P. O. A. D. P.
METHODIST HEALTHCARE

POADP APPLICATION

Re: Methodist Healthcare

POADP # 585

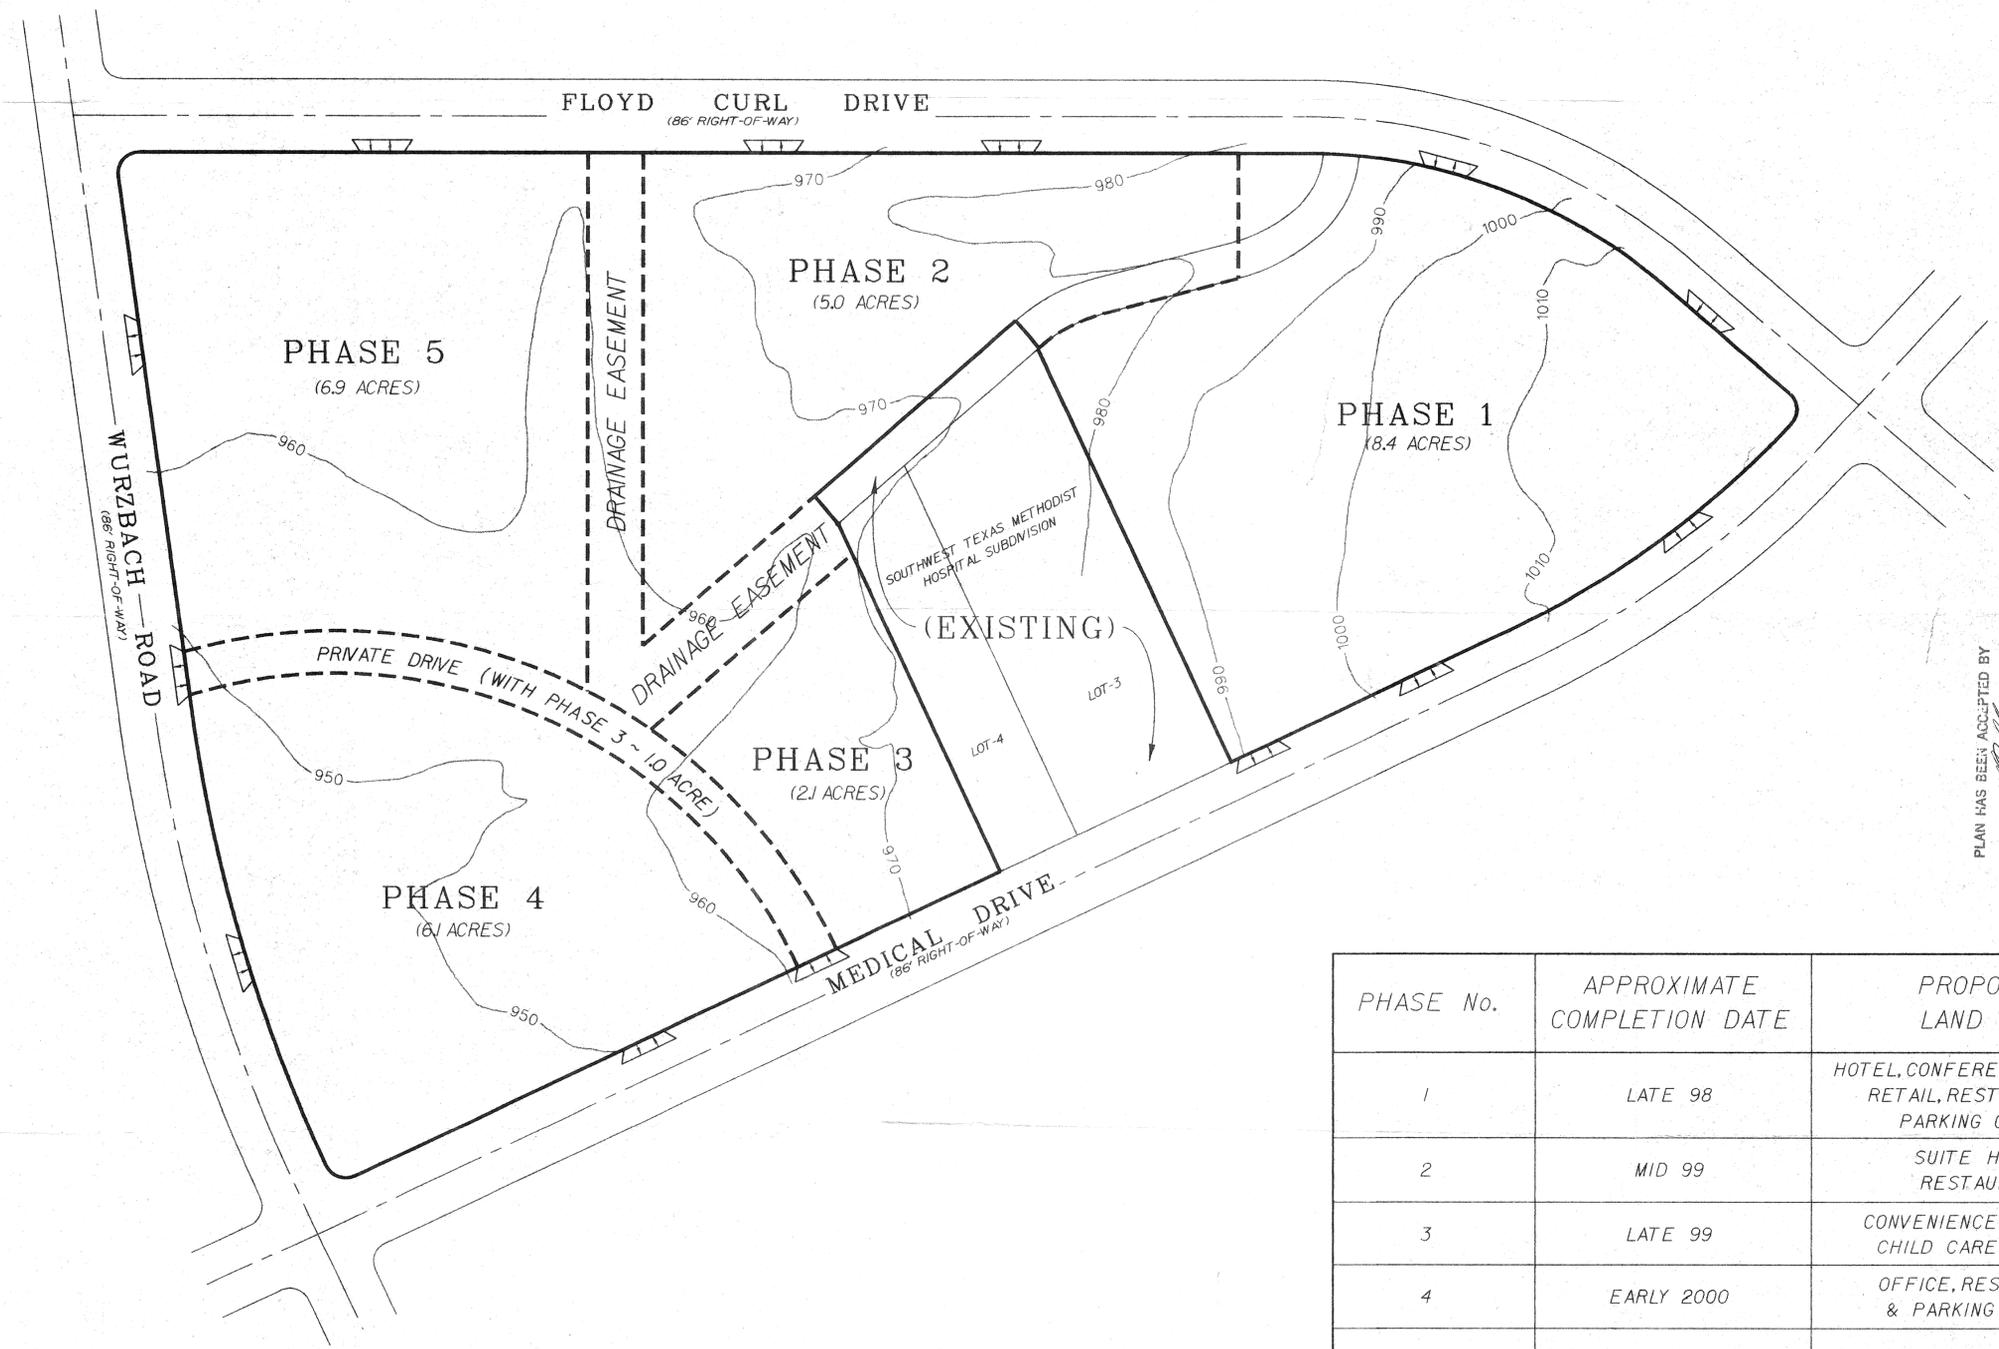
- Based on the topography, a Flood Plain Study and drainage review will probably be required during the platting process.
- This development will need to comply with tree preservation ordinance #85262. For additional information about these requirements you can contact Building Inspections at 207-7102.
